**WATER SUPPLY EVALUATION  
FOR PROPOSED PROJECTS  
ALONG THE I-84 CORRIDOR**

Idaho Power Company

November 14, 2012

REVIEW OF IDWR'S MAY 31, 2012 STAFF REPORT

Figure 2

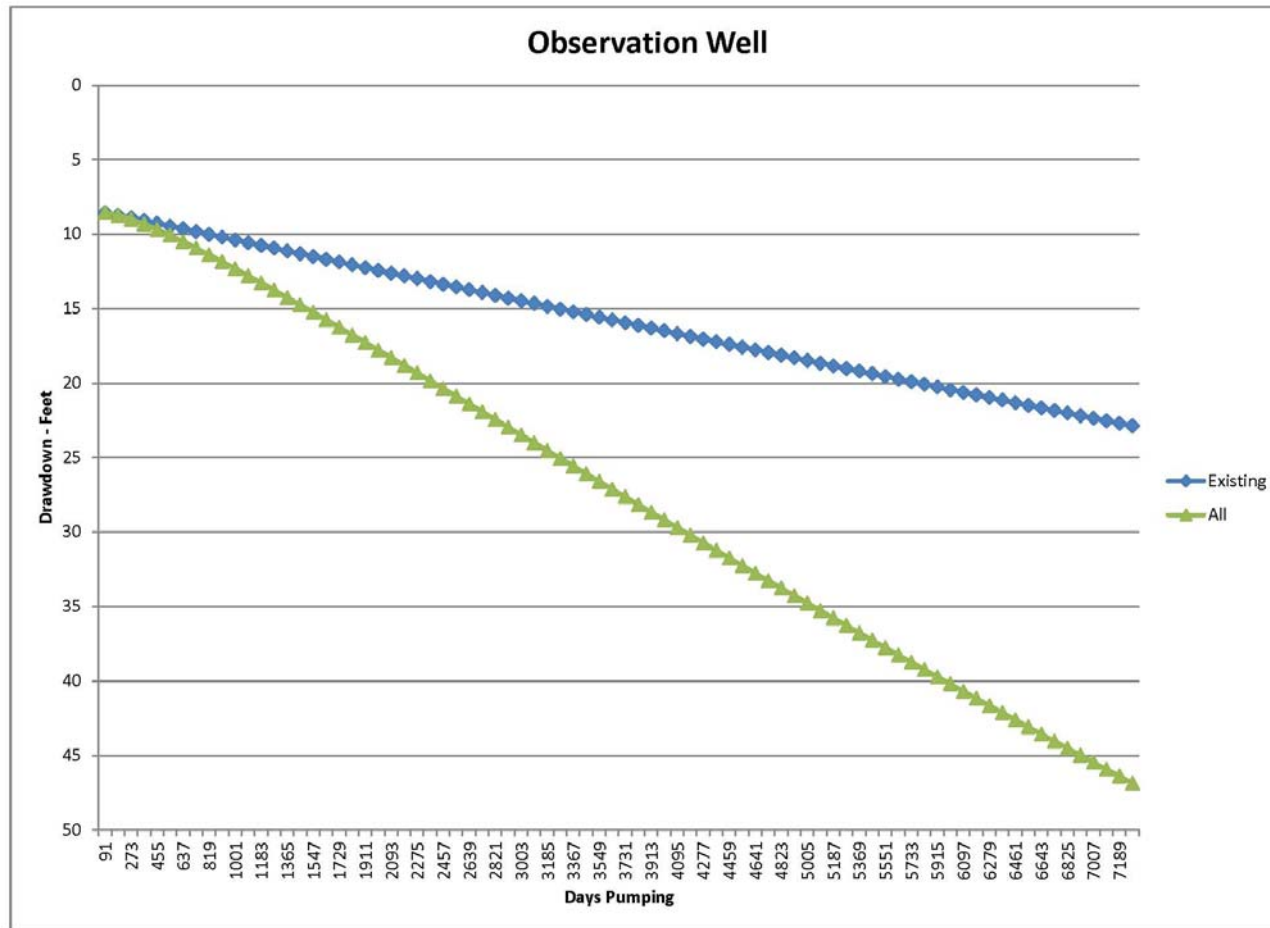
To estimate the impact of continued pumping by existing water users the program was run for an additional 20 years. A simulated observation well was placed near the center of Sec 19 Twp 1S Rge 5E, B.M. which is near the location of the fault identified by Bond and near the boundary of the study area and the comparison area<sup>2</sup>. The results of the additional simulated pumping are shown in Figure 2 below. The analysis shows an estimated drawdown at this location of about 8 feet after 20 years of pumping the existing wells. When pumping of those wells continued for the second 20 years the analysis shows an increased rate of drawdown of about 15 feet for a total drawdown of about 23 feet by existing water uses after 40 years of pumping.

The existing permits, transfers and new water right applications were then added to the analysis and the second 20 year simulation was run a second time. The projected drawdown is shown on Figure 2 below as "All" and shows a drawdown of about 47 feet in the second 20 years, about double the drawdown that is forecast if existing conditions remain unchanged.

Recognizing the Theis analysis is a simplification of the actual conditions that may exist in both the study area and the comparison area, it does point to the potential interconnection between the two areas. Such an interconnection could cause some of the net recharge IDWR identified in the study area to not be available for future appropriations because it is part of the interconnected supply already being used by existing ground water users. It also shows the potential for any new water uses in the

Figure 3

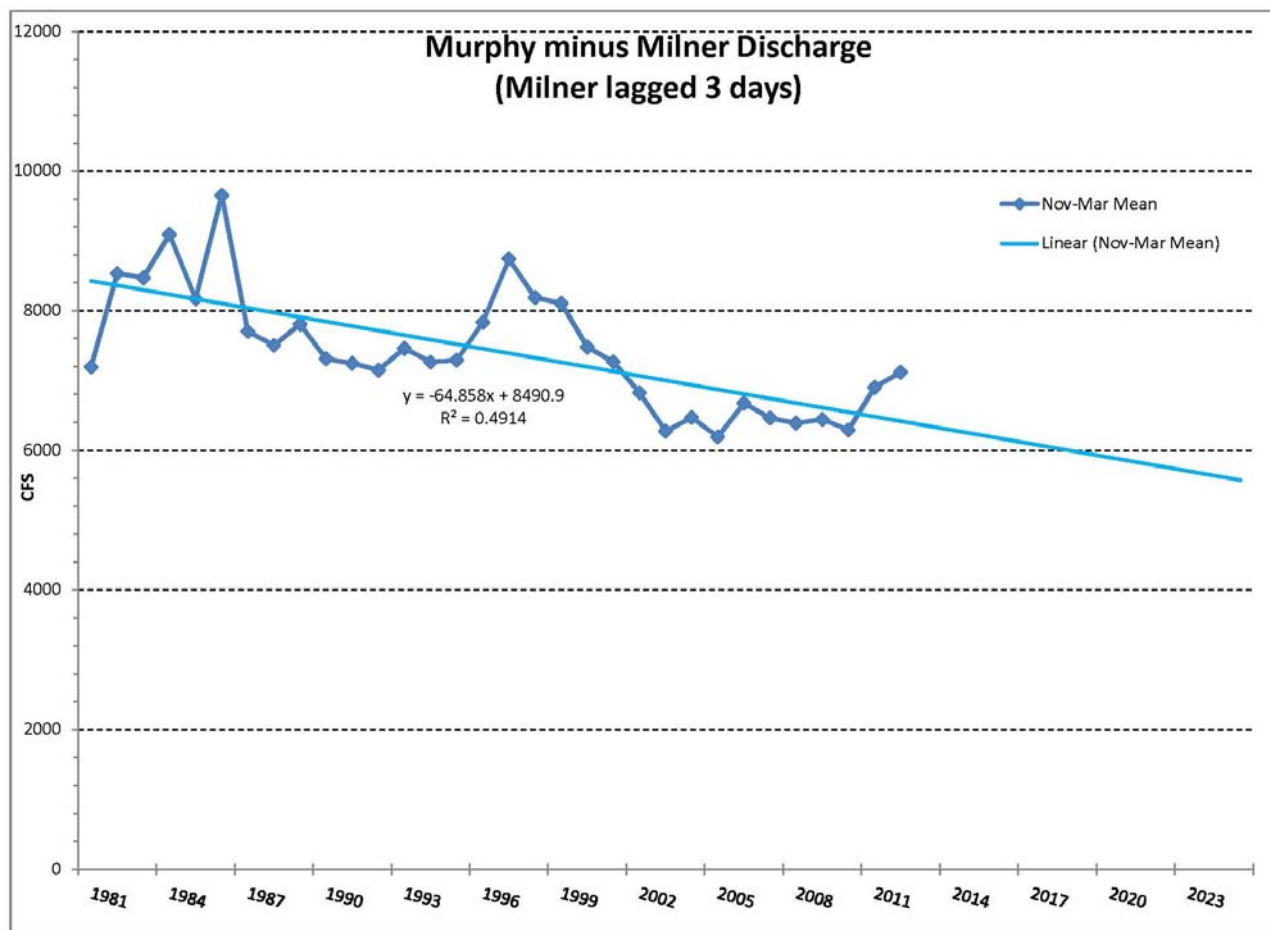
Figures 3 and 4 below were produced using mean daily flows for Murphy and Milner, modified as described above, and averaged for the winter and summer periods respectively. Figure 3 suggests the average mean daily winter discharge at Murphy, as modified above, has declined about 2,000 cfs since 1981 and is continuing to decline at about 65 cfs per year. Projecting this rate of decline forward from 2012 for 13 years suggests the average mean daily flow for the winter of 2025 will be 5,600 cfs, the winter minimum flow established by the Swan Falls Agreement and approved by the Idaho Legislature.

Figure 4

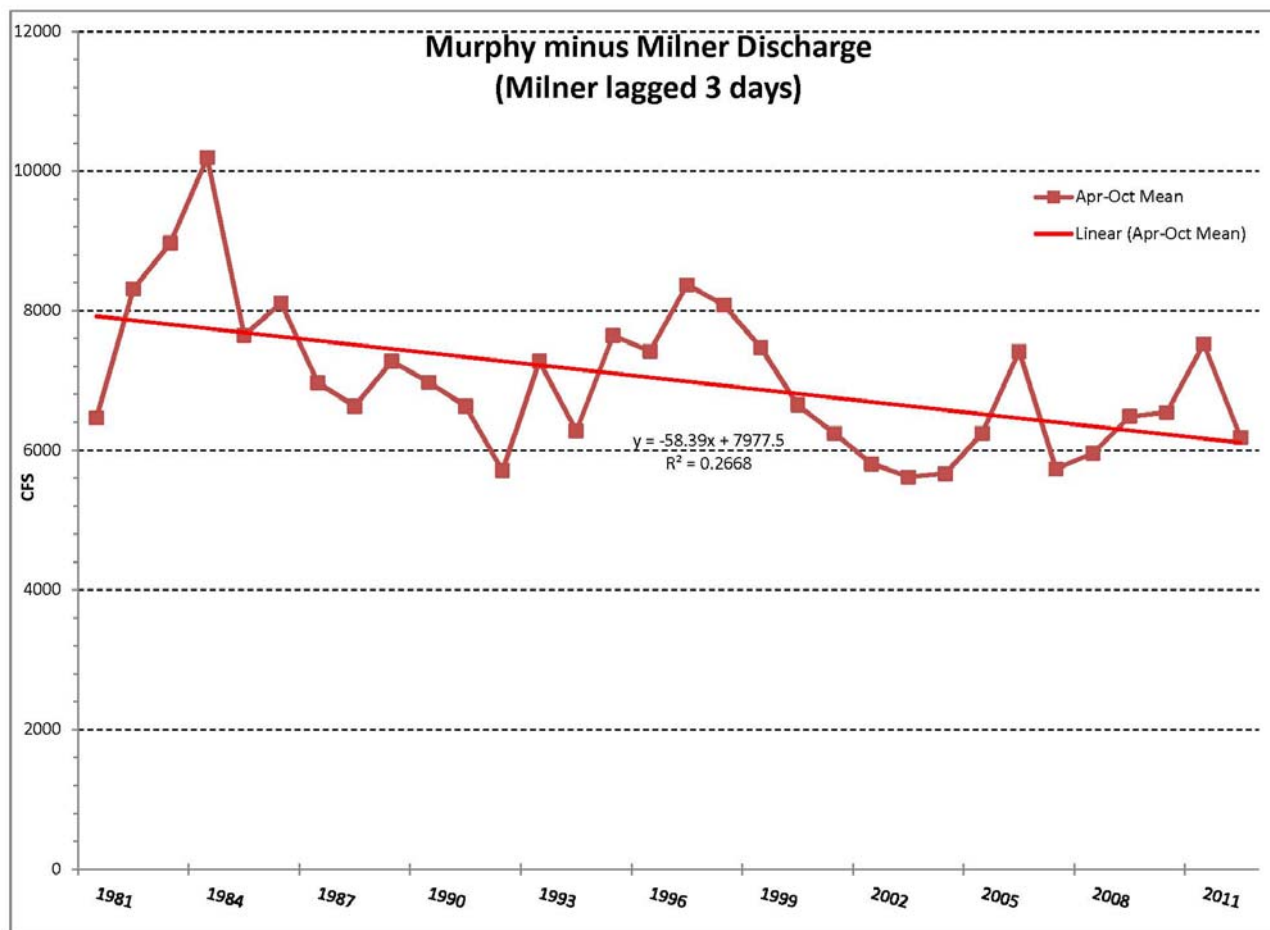
Figure 4 suggests the average mean daily summer discharge at Murphy, as modified above, has declined about 1,850 cfs since 1981 and is continuing to decline at about 58 cfs per year. The average summer flows are still high enough there is no immediate danger the entire average summer flow will decline to 3,900 cfs, the summer minimum flow established by the Swan Falls Agreement and approved by the legislature. Summer flows are, however, quite variable, and time periods shorter than the 7 months from April through October were examined to determine if one period was consistently lower than the entire summer period. To perform that analysis, monthly averages of mean daily summer flows at Murphy, as modified, were calculated for the months April through September with the lowest month being July.
